RHODE ISLAND DEPARTMENT OF TRANSPORTATION

RHODE ISLAND CONTRACT NO. 2024-CB-048 FEDERAL-AID PROJECT NO. BRO-044H(002)

BRIDGE GROUP 44H - NONQUIT POND

ADDENDUM NO. 1

BRIDGE NOTES - 2

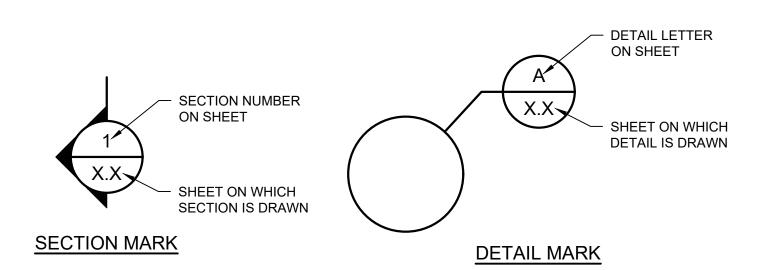
Question 4. "The 2024 RI Standard Specifications defines mass concrete as any elements for which the concrete dimensions in three directions is 4 ft or greater. Plan sheet #17 calls for class MC 5,000psi concrete for abutment stems and wingwalls and MC 4,000psi concrete for pile caps and wall caps. None of these sections are 4 ft or greater in three dimensions. In fact, the wall stems are only 1.5 feet thick. Please clarify the concrete requirements and consider eliminating the class MC requirements, which appear unnecessary for these elements. Class MC concrete slows down the progress of the work and adds extra cost since it cures slower and requires additional engineering and construction requirements."

Answer: Plan Sheet 17 will be updated aby addendum. Abutment and wingwall pile cap concrete shall be Class XX ¾" f'c 4000. Abutment and wingwall stem concrete shall be Class HP ¾" f'c 5000.

Delete Plan Sheet 17 in its entirety and replace it with revised Plan Sheet 17 (R-1) attached to this Addendum No. 1. The sheet has been revised.
